## **ADDENDUM NO. 001**

Kern Community College District

Addendum Dated: 12/11/2025

You are hereby notified of the following changes to  
Cerro Coso Community College Physical Education Outdoor Complex Renovation Ph II  
Artificial Turf Installation.

# Attachment A

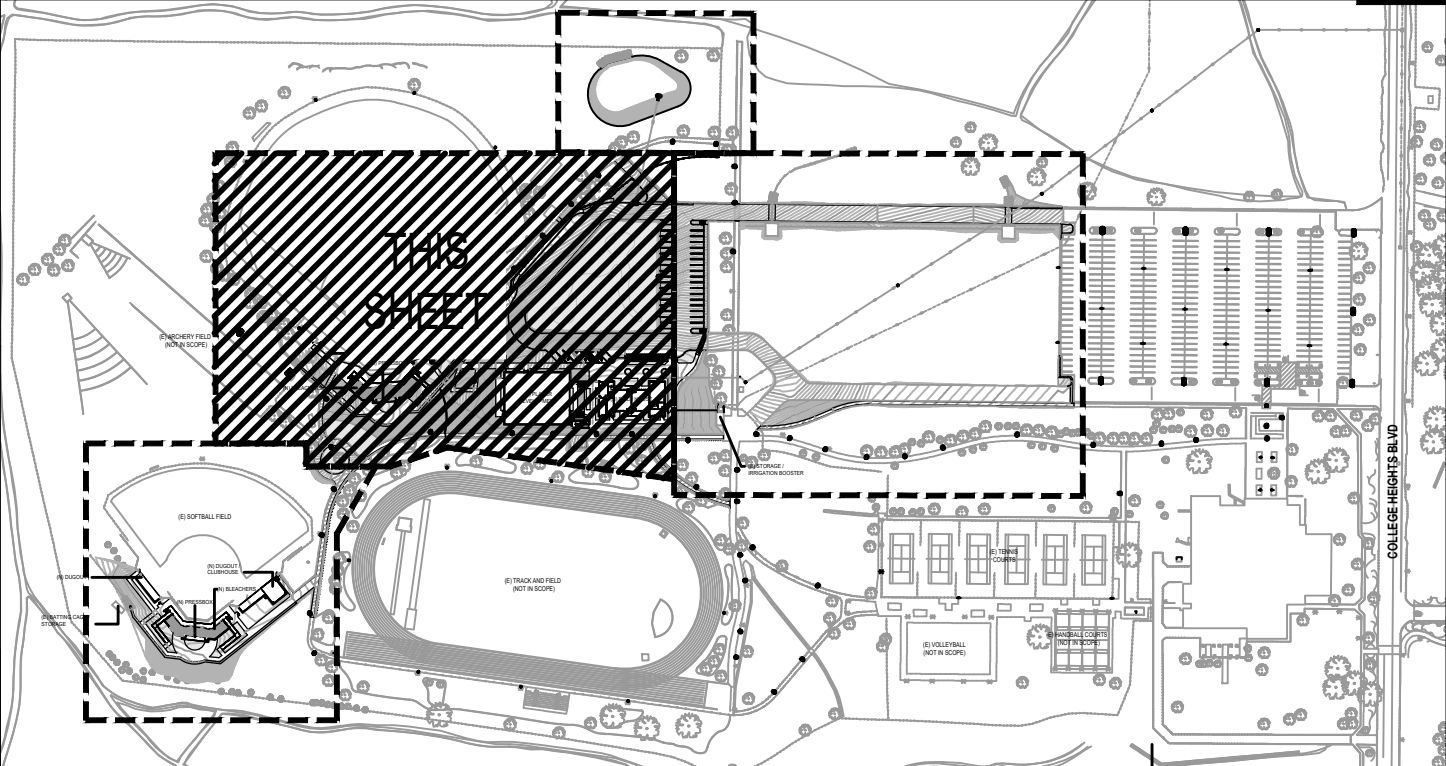
Item No. 1: See Attachment A  
Sheet (E) Baseball Field, East boarder mow curb at baseball to match  
existing sidewalk surface.

1B: CONCRETE MOWCURB  
SEPARATING TURF FROM SHRUB AREA

Match mowcurb to sidewalk surface

# Attachment B

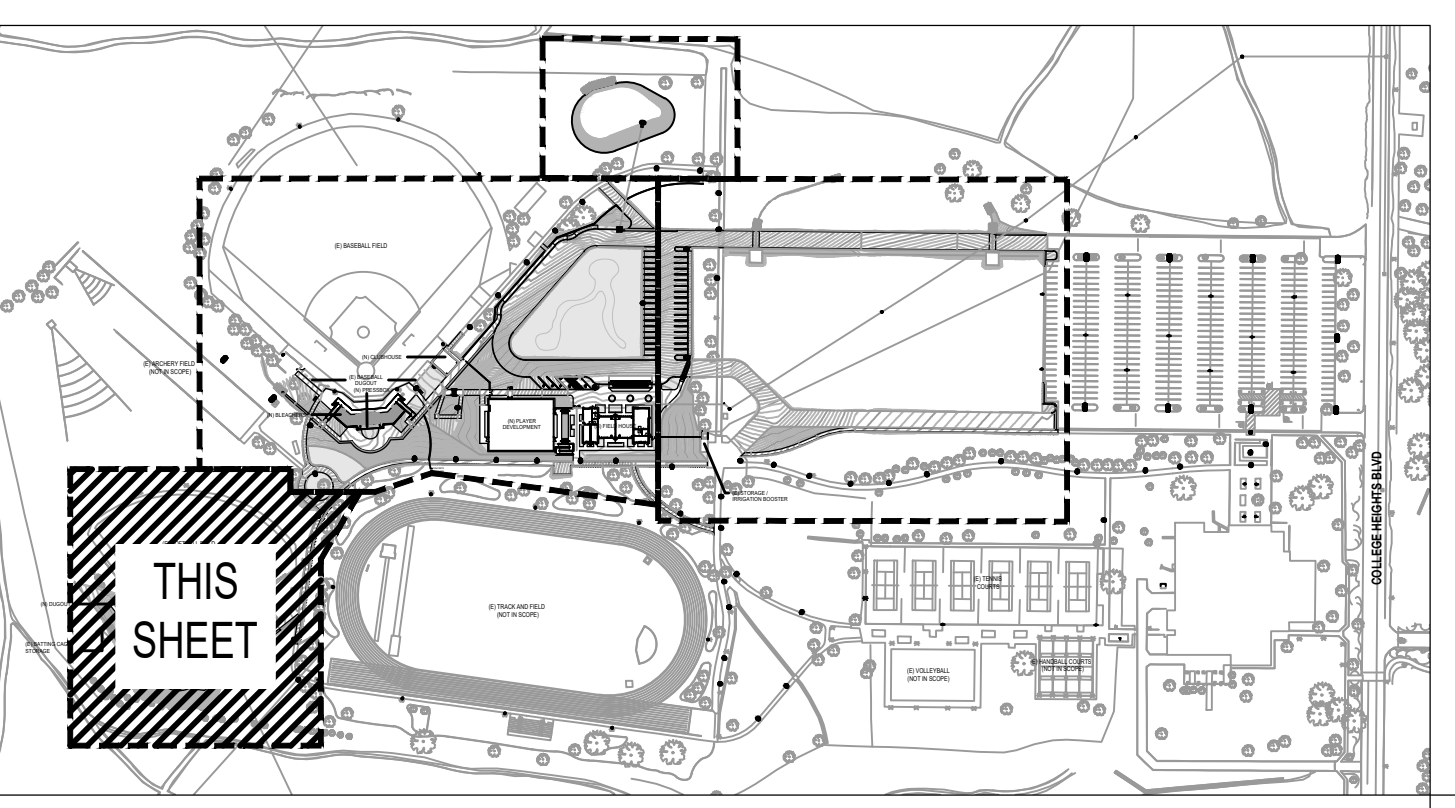
Item No. 2: See Attachment B  
Sheet (E) Softball Field,  
1. Add three additional mow curbs at the softball field locations in  
orange. Mow curbs to match existing sidewalks except at softball  
dugouts. At the dugouts match the higher finished surface of the  
dugout or sidewalk, whichever is higher. Keep height of mow curb  
(Blue) at finished surface of sidewalk.  
2. Increase width of concrete equipment pad to 13 feet.

Item 1  
Additional Mowcurbs

Item 2  
2D: CONCRETE  
EQUIPMENT PAD: 13' X  
35' X 6" THICKNESS
